Standardized Nuclear Unit Power Plant System

SLNRC 82-018 FILE: 0543.1
SUBJ: Callaway SER-Proposed
Technical Specification

Reference: NUREG-0830, Callaway Safety Evaluation Report

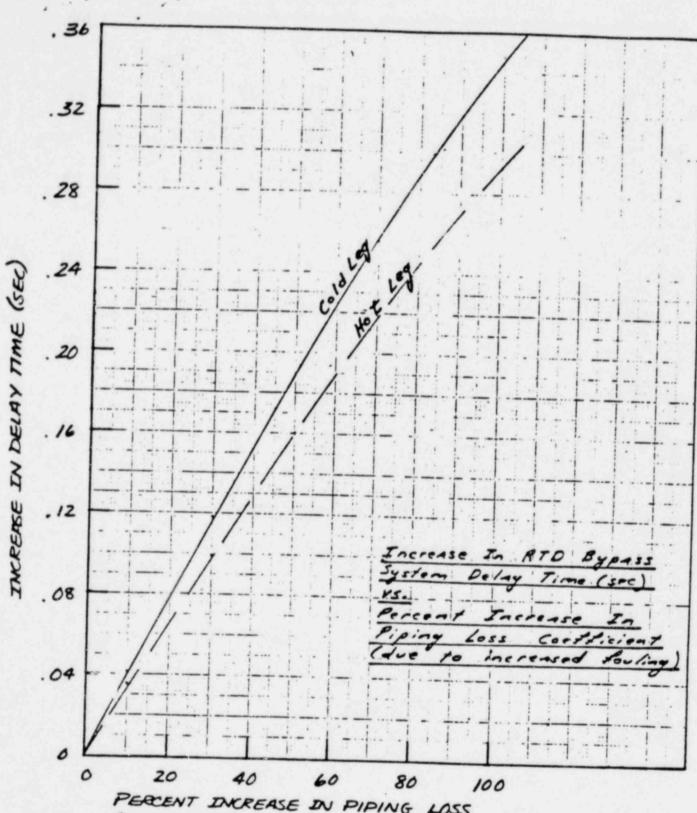
Figure 1 is a plot of the increase in the hot and cold leg transport delay time as a function of the percent increase in piping loss coefficient due to fouling. Loop 1 was used as a representative loop to generate this plot but Loops 2, 3, and 4 behave similarly. Summarizing this part of the evaluation, the hot led loss coefficients would have to increase by the amounts listed below before the 1.0 second maximum delay time would be reached.

Loop	Increase in H.L. Loss Coefficient Necessary for 1.0 Sec. Delay Time	
1	100%	
2	103%	
3	106%	
4	68%

Changes in loss coefficients of this magnitude are not credible.

Based on the above evaluation, the SNUPPS Utilities do not believe that the additional surveillance suggested by the NRC Staff is justified. Your attention to this matter is appreciated.
